Approval Notes

**3980-3982 Austell Powder Springs Rd SW
Powder Springs, GA 30127
1":40'**

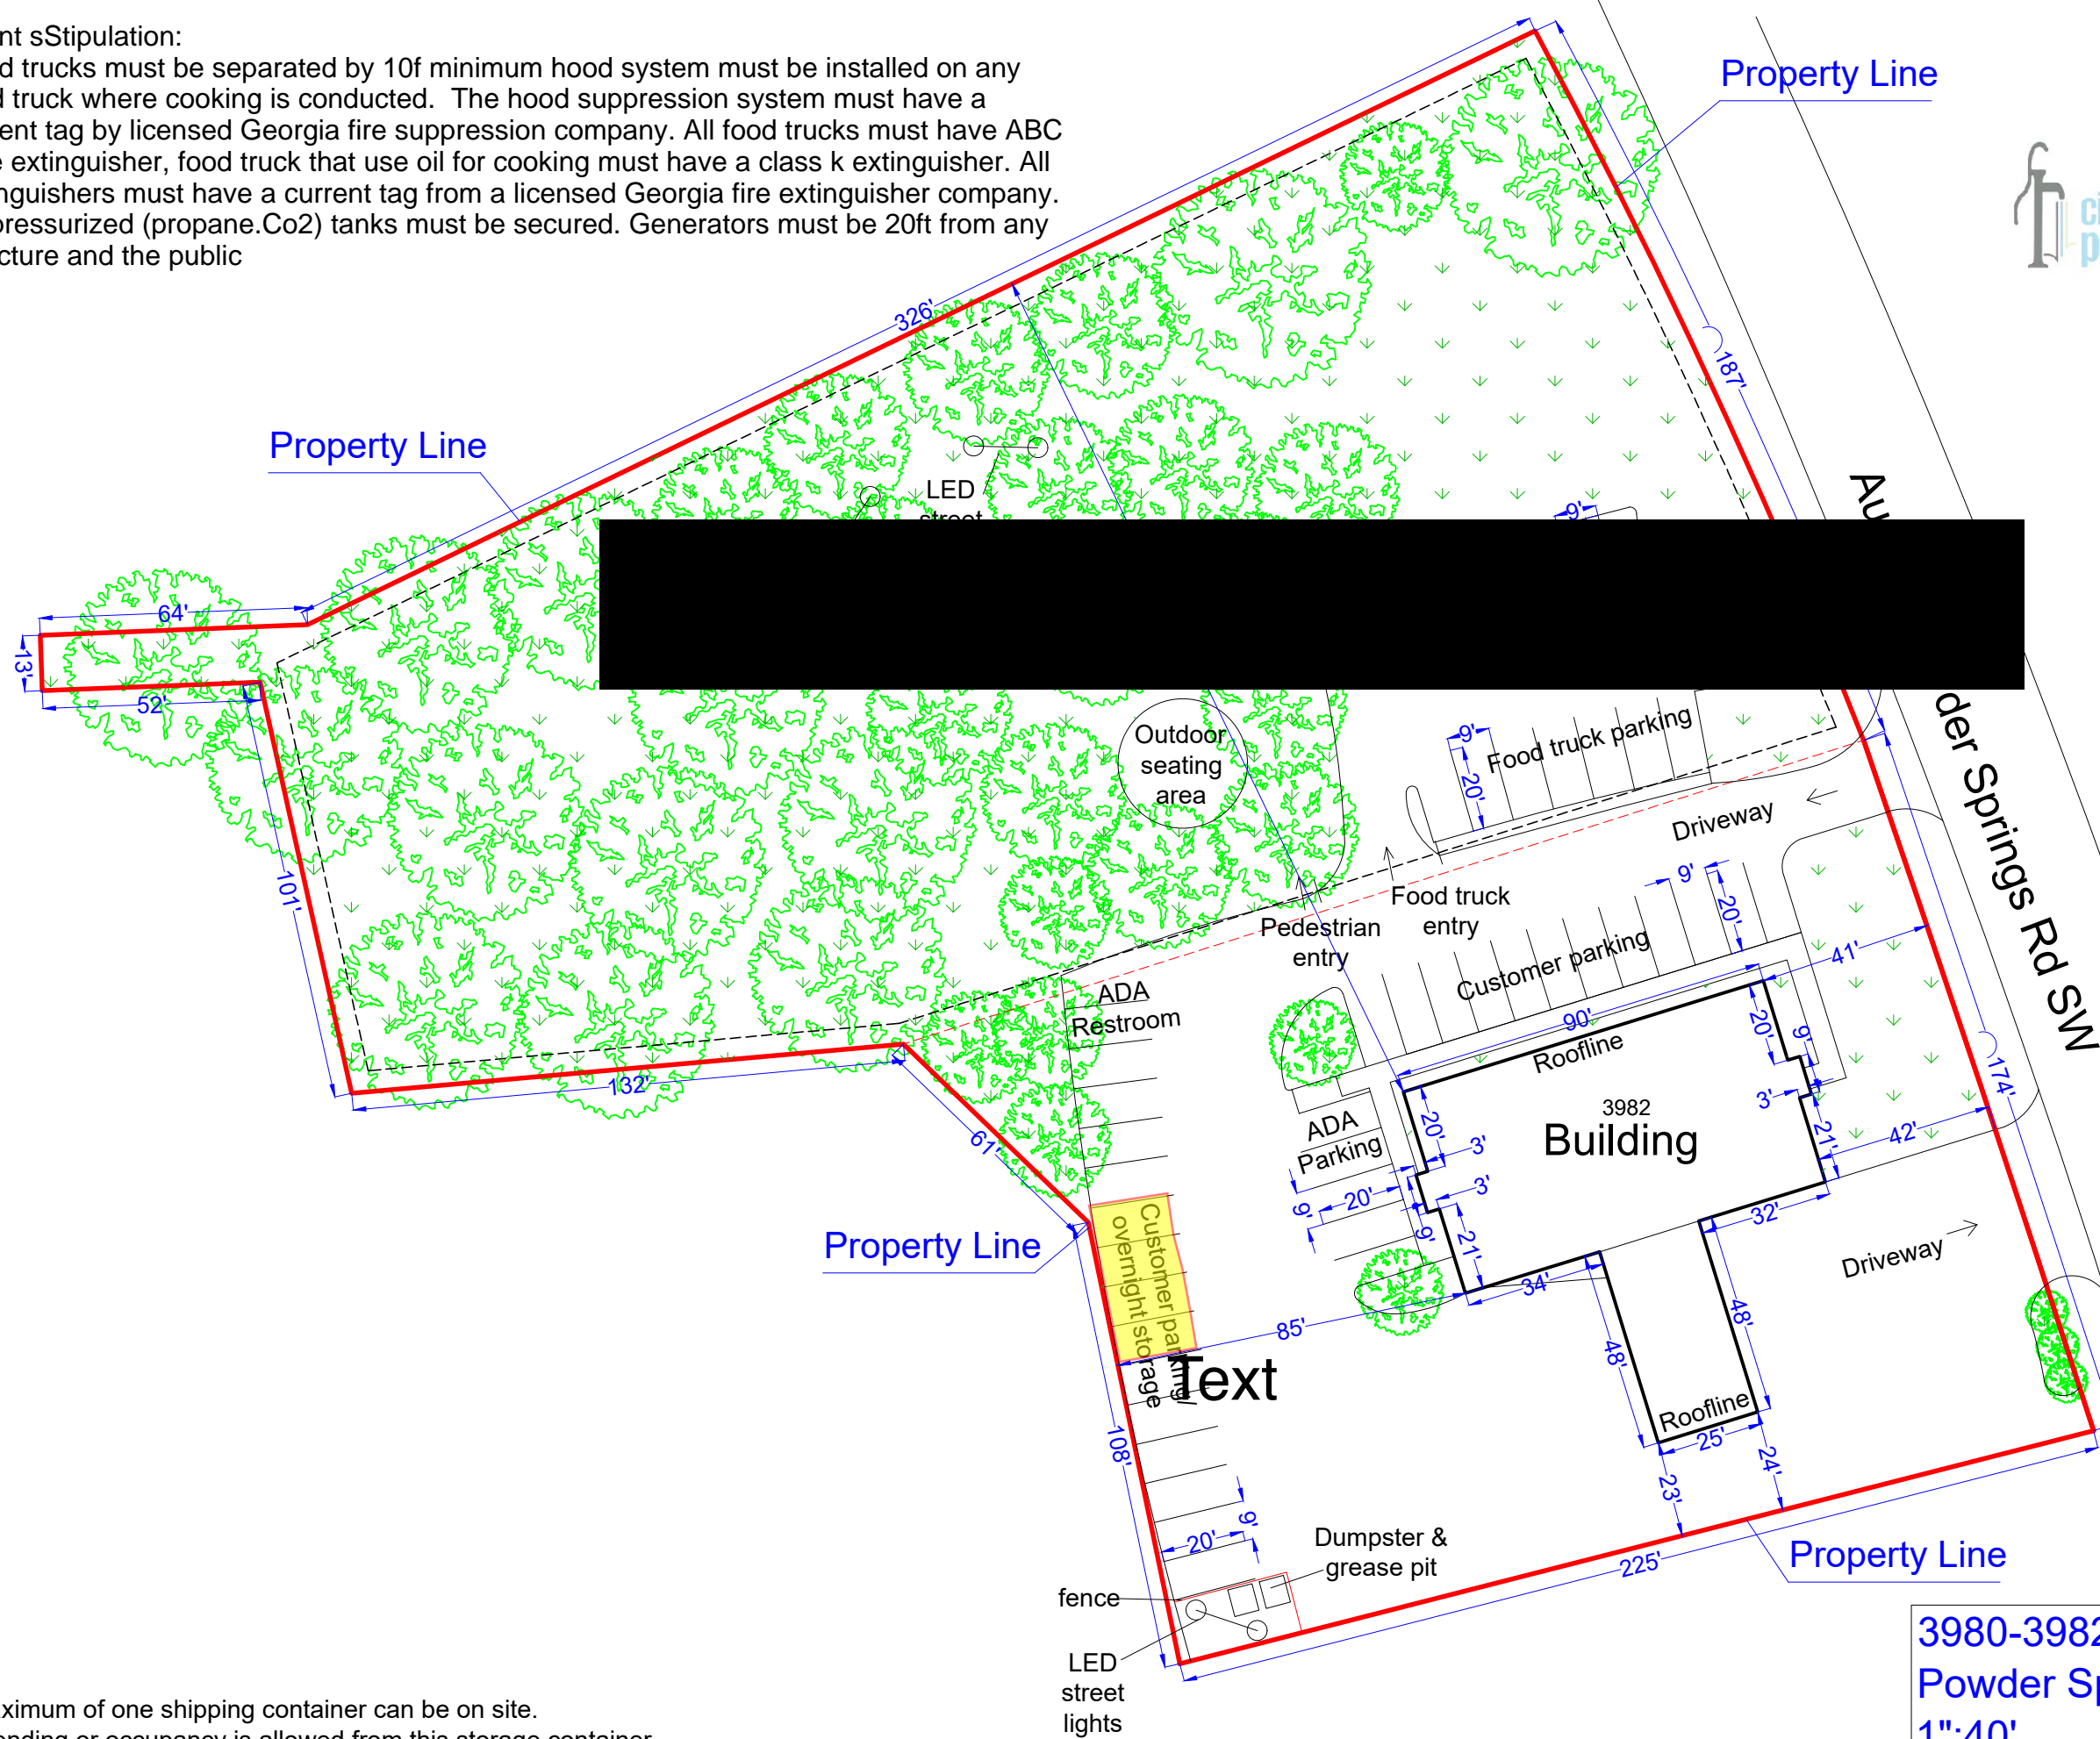
1)ADA parking must include 5' aisle in the center of two spaces as detailed below.

3)Storage for Food Trucks or grills must be marked by signage onsite and is limited to area shown in yellow on the site plan. Only Cobb County approved trucks or grills may be stored on the property. Personal grills are not permitted to be stored onsite.

5)The maximum number of trucks allowed in operation on the site is 10. Parking spaces shown in area labeled Food truck parking on the site plan are standard parking spaces and do not indicate the layout of parking for food trucks.
